MEMORANDUM
(620922)

RE: Historic Covered Bridge Preservation Committee
Waitsfield Village Covered Bridge
STP EH 08(6)
Meeting Minutes

DATE: June 9, 2011

Pre-Fabricated Glulam Beams and Deck

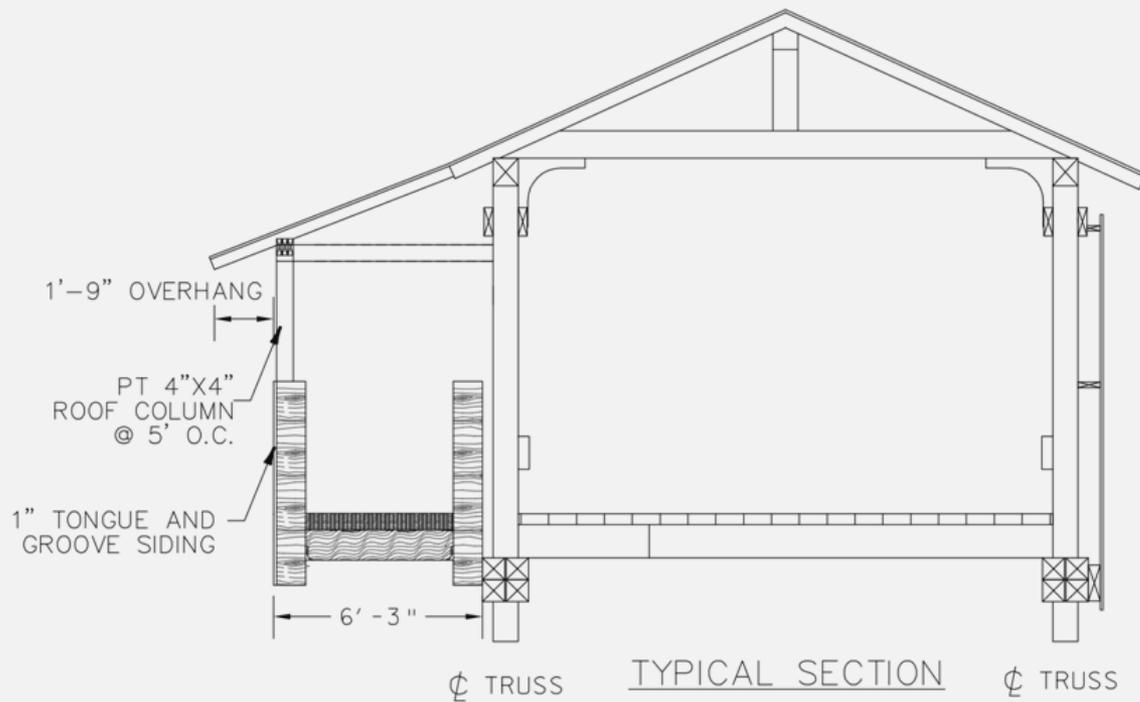
Eric Gilbertson prefers the glulam beams, because they won't detract from the actual historic truss.

The discussion of sidewalk alternatives concluded with Scott Newman stating that either the steel truss or glulam beam options would be acceptable in order to issue a Section 106 clearance, but that the trussed arch and the arch/truss structures would not be acceptable.

Pre-Fabricated Timber Trussed Arch

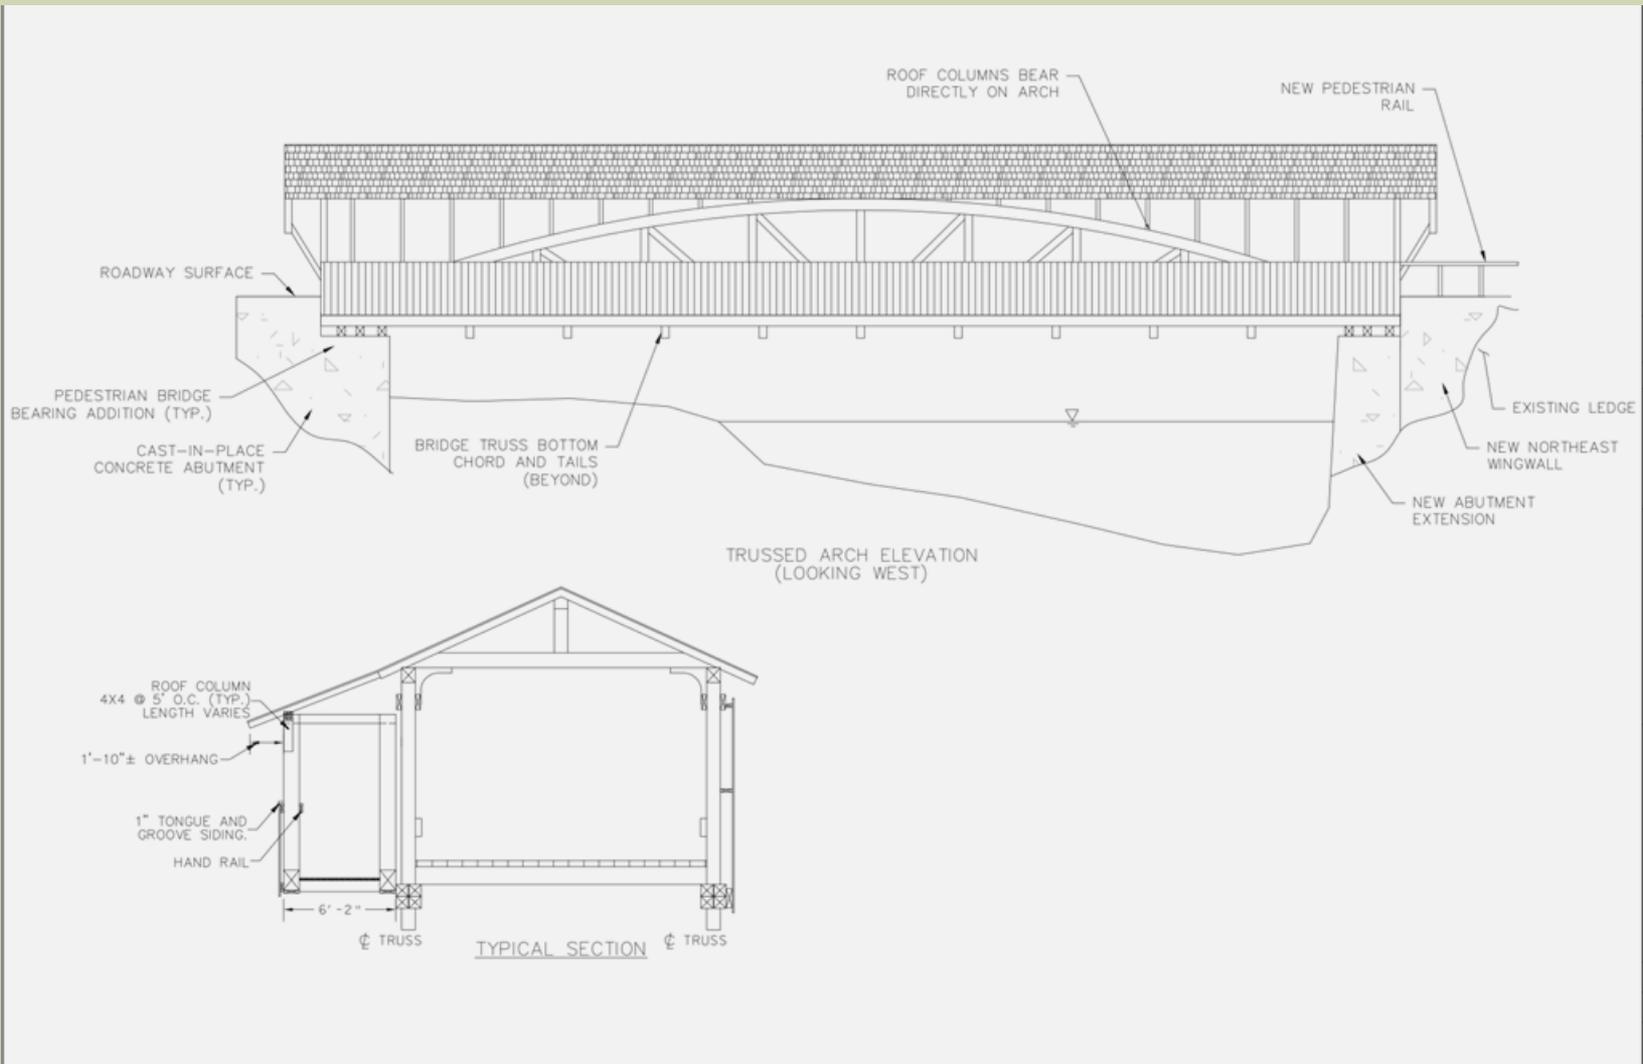
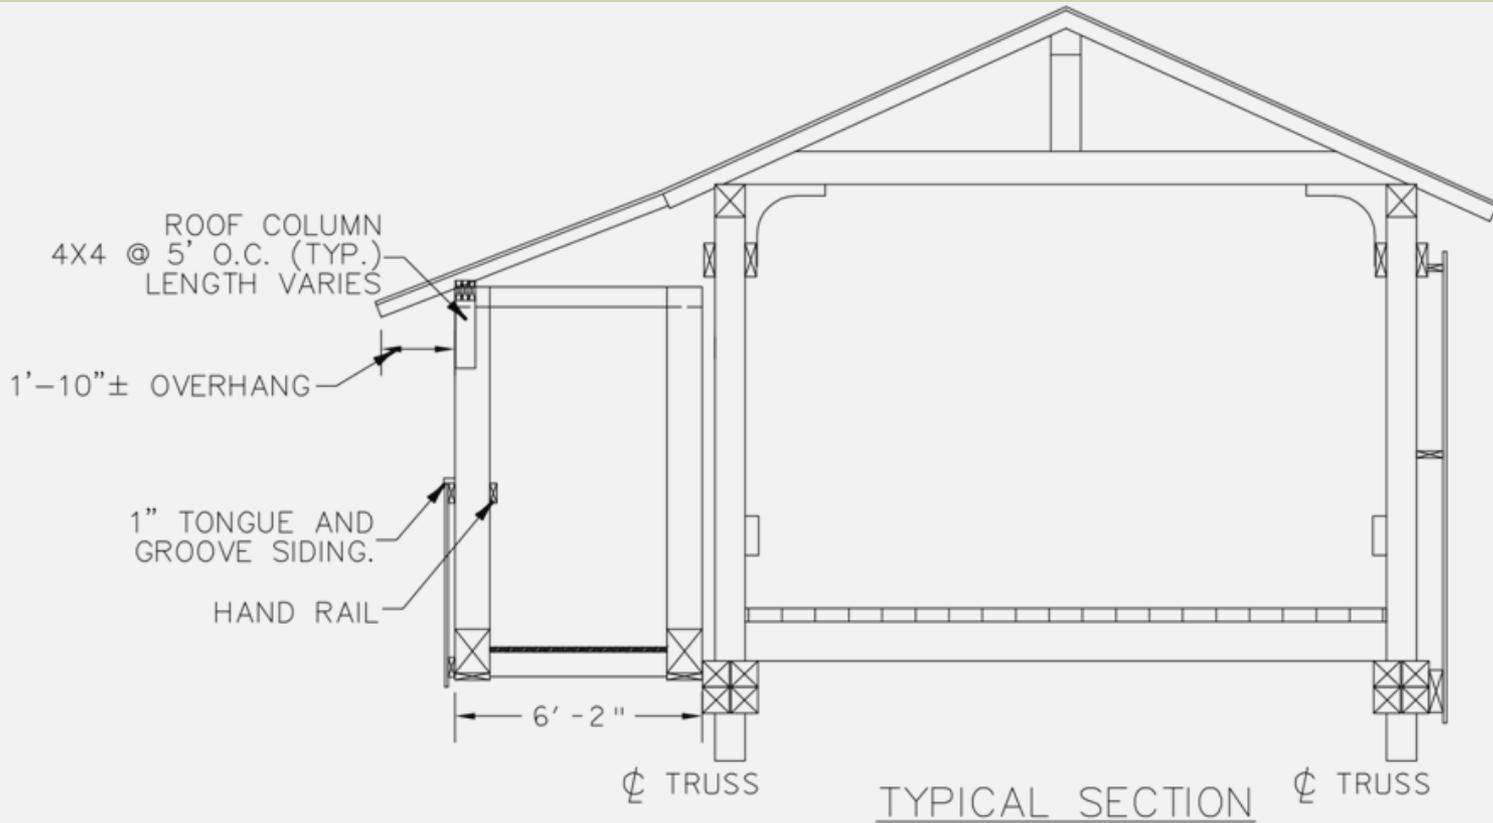
There was much discussion about materials and visual impact of the new sidewalk bridge. Scott Newman had concerns that a new trussed arch or the sawn lumber arch/truss structures would detract from historic context of the original bridge. He noted you don't want to confuse the actual historic elements with replicated historic elements, and you don't want to visually distract from the actual historic elements.

Scott Newman confirmed Eric's assertion that a new trussed arch or the sawn lumber arch/truss structure will not meet the Secretary of the Interior Standards.

John Weaver stated that he thought the arch option would accentuate the existing sag of the main trusses.

Pre-Fabricated Steel Truss

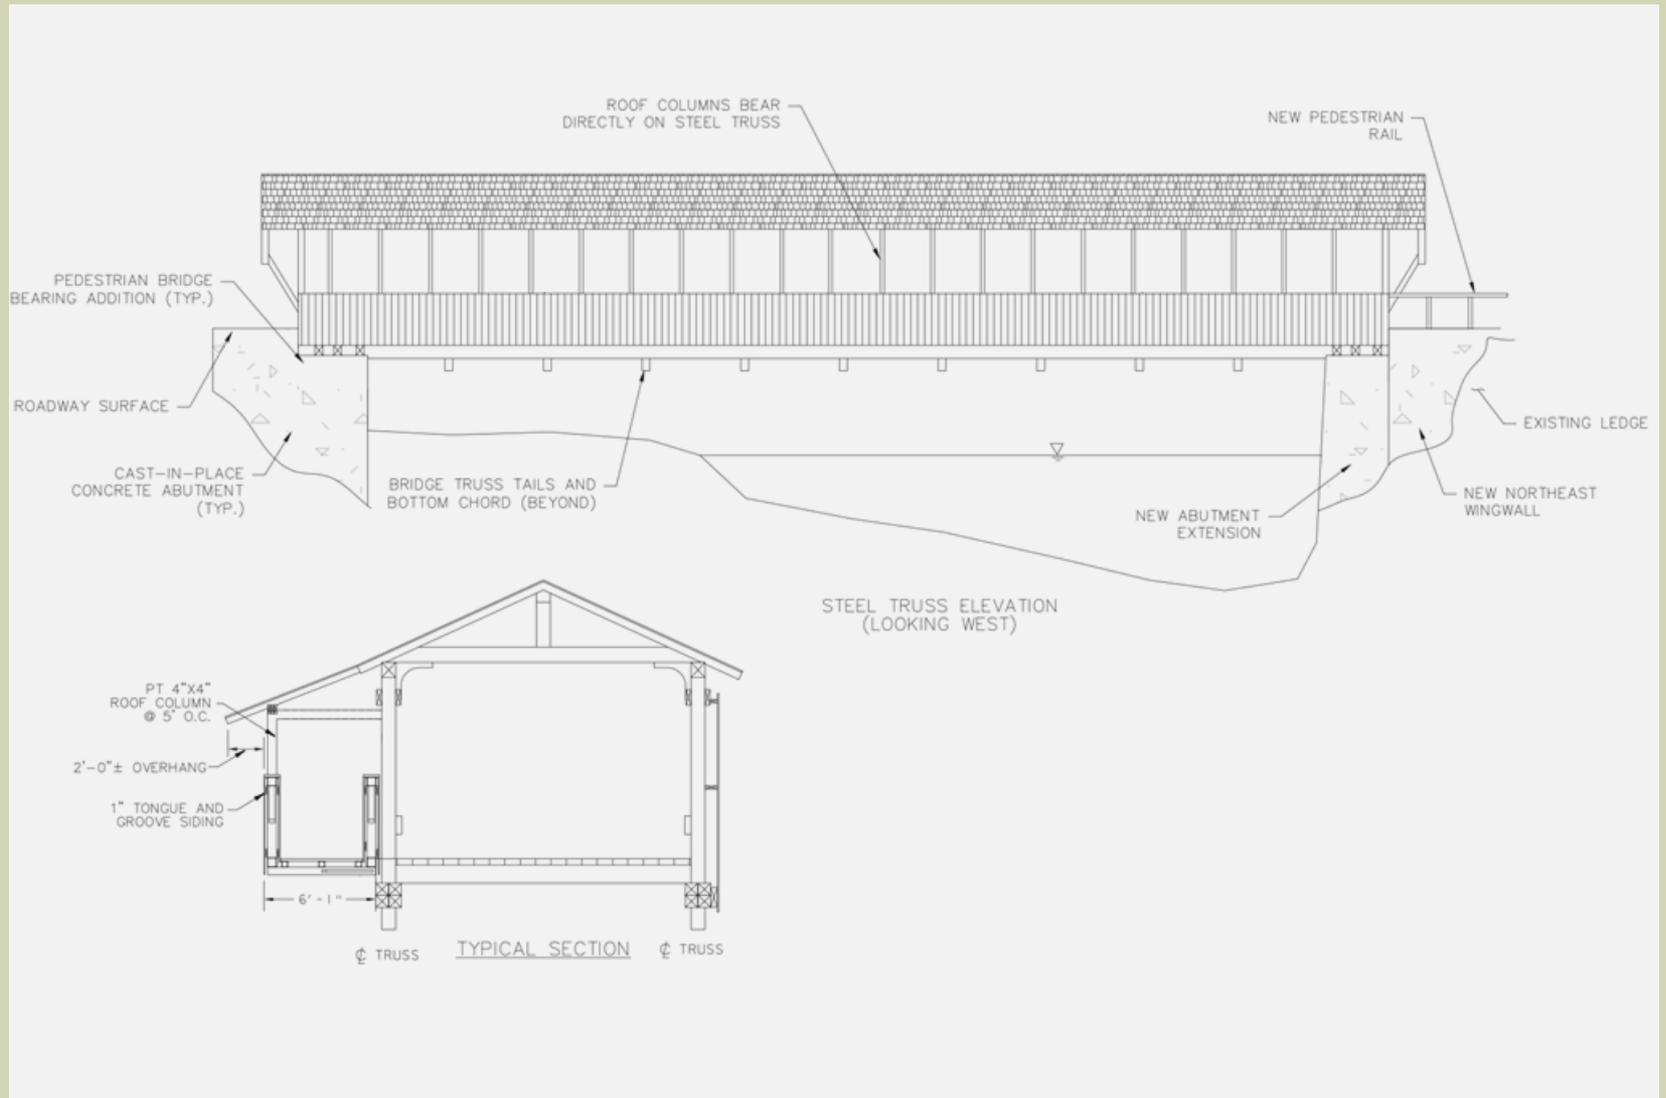
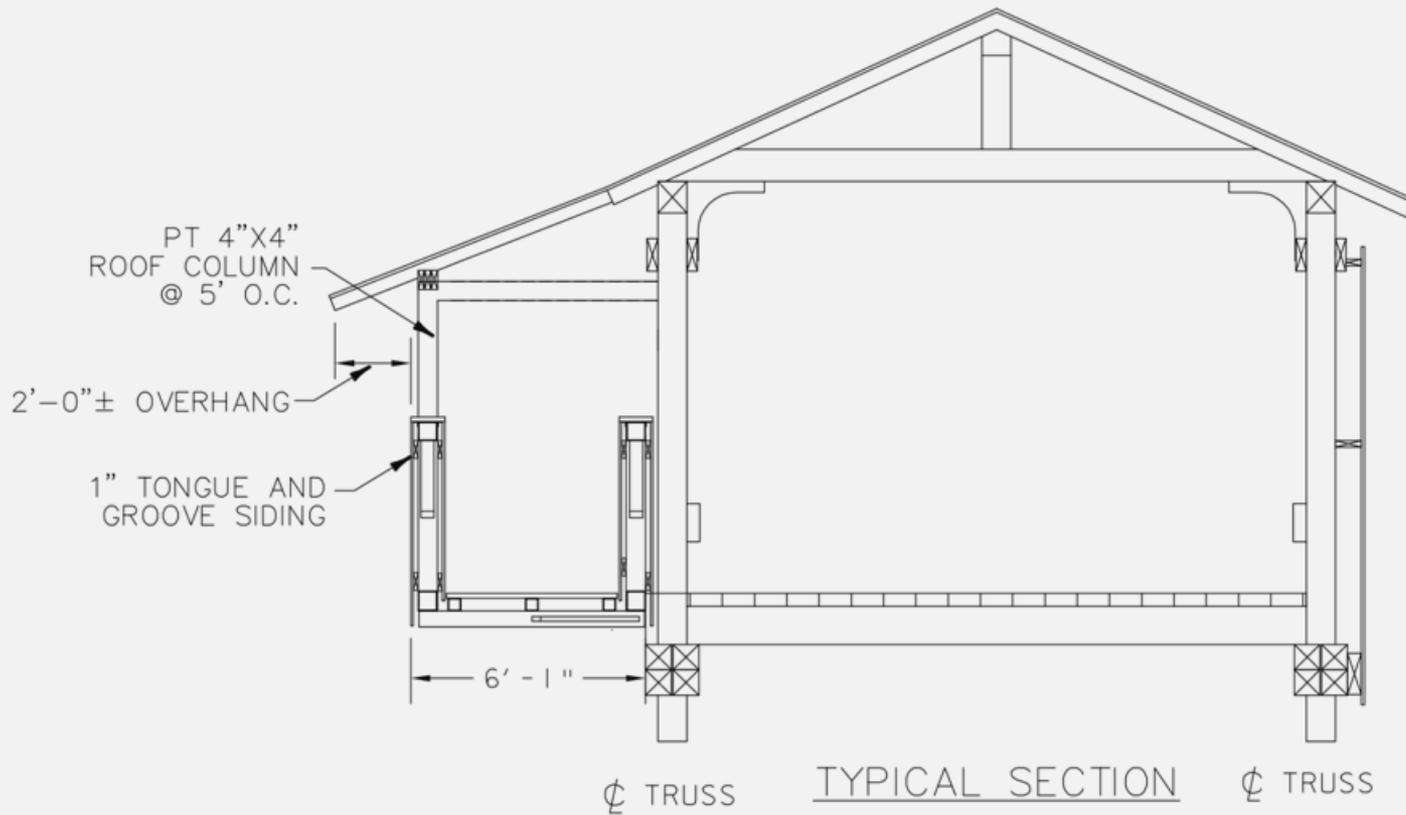
Mike Hedges expressed his concern about a steel truss being hidden under wainscoting, and noted that it should be accessible and galvanized or painted.

Bob Durfee stated that steel is best option for longevity and John Weaver agreed. Charlie Hosford disagreed, and stated that he thought timber is the best option for longevity (as evidenced by the long standing timber bridge).

Sawn Lumber Queen Post Truss and Burr Arch

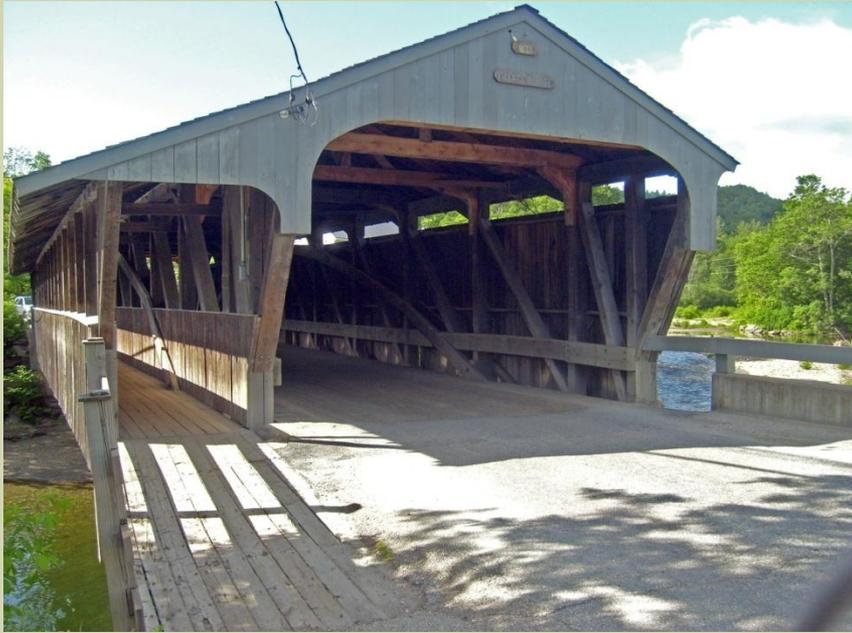
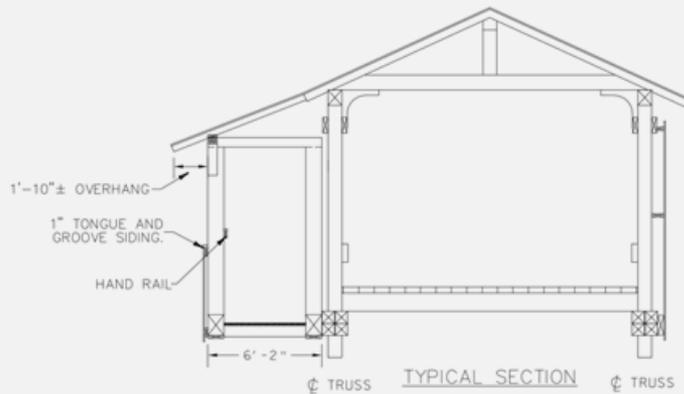
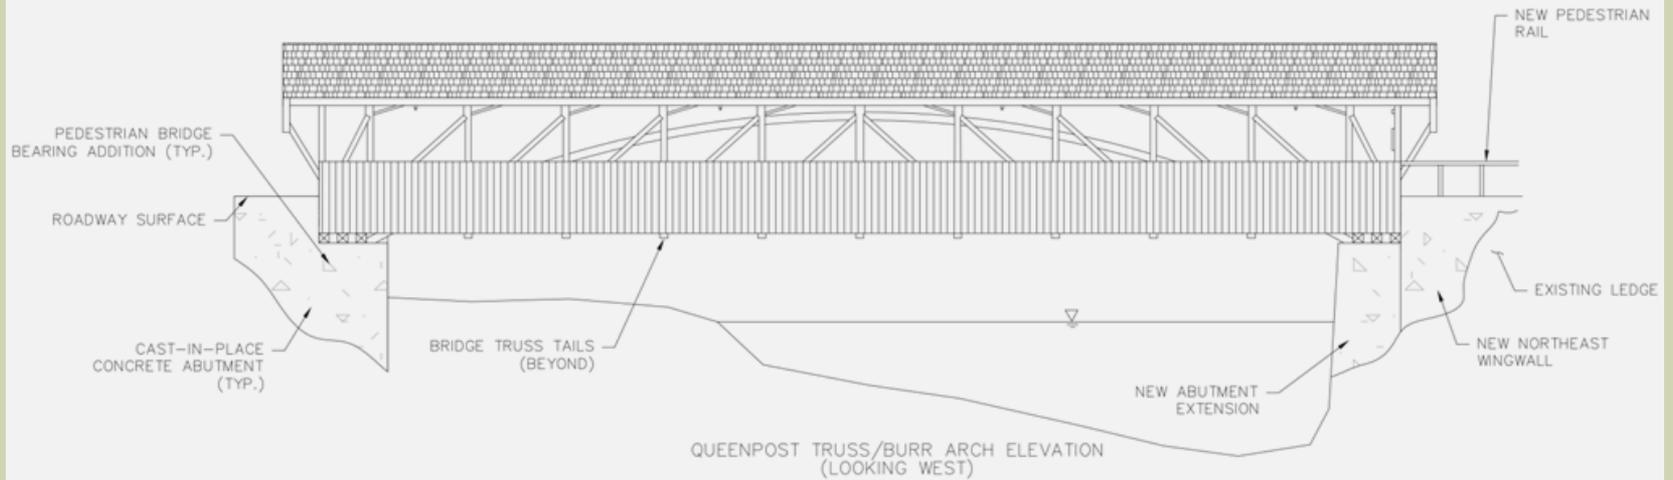
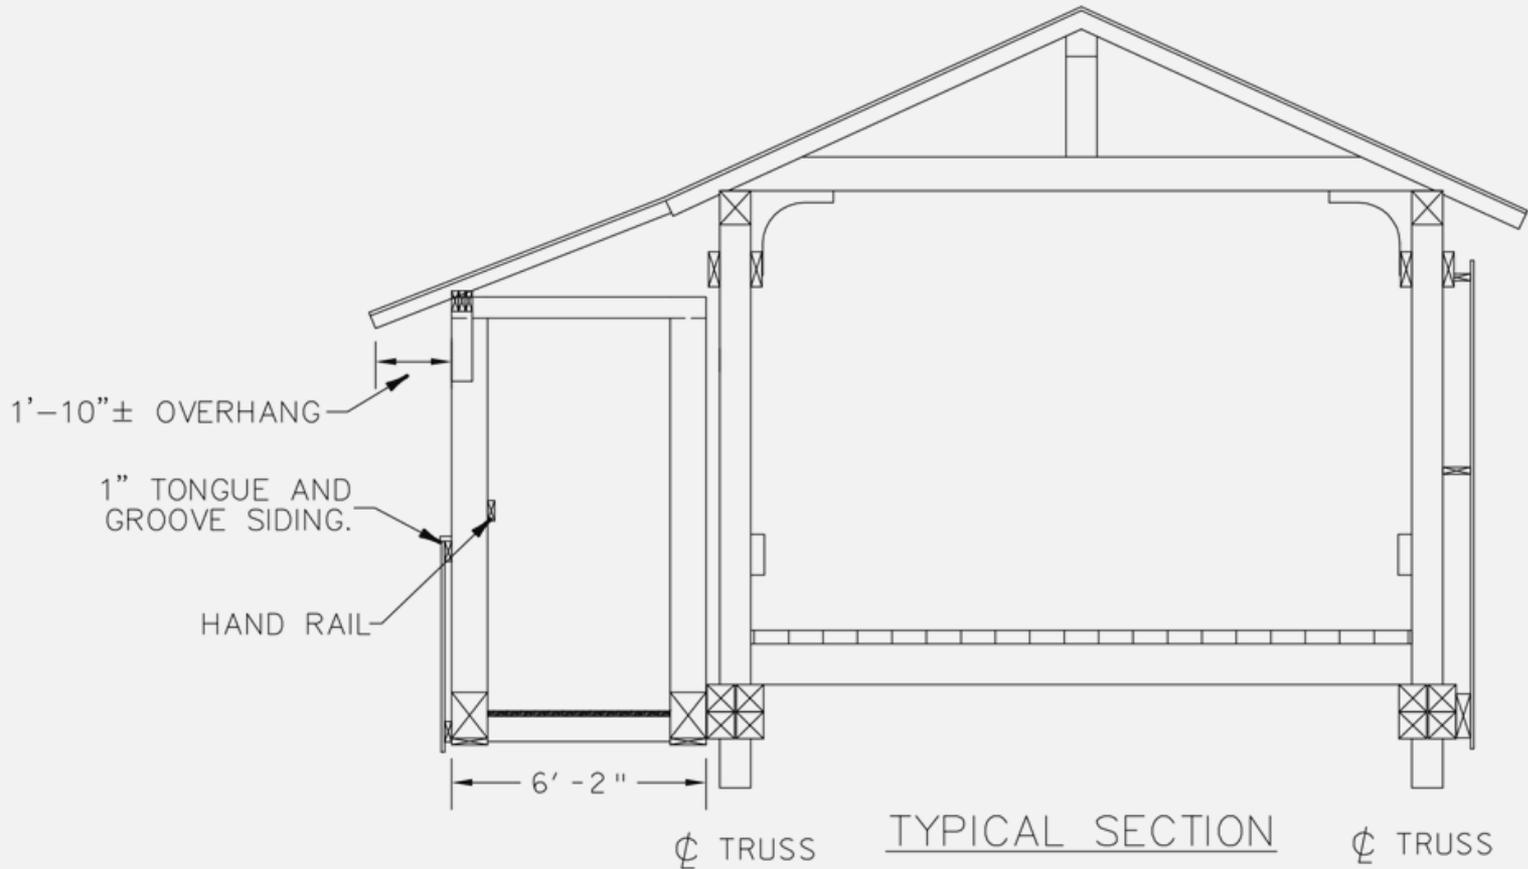
Charlie Hosford expressed his desire to have a custom made wood structure, and does not prefer the pre-fabricated laminate products, or steel.
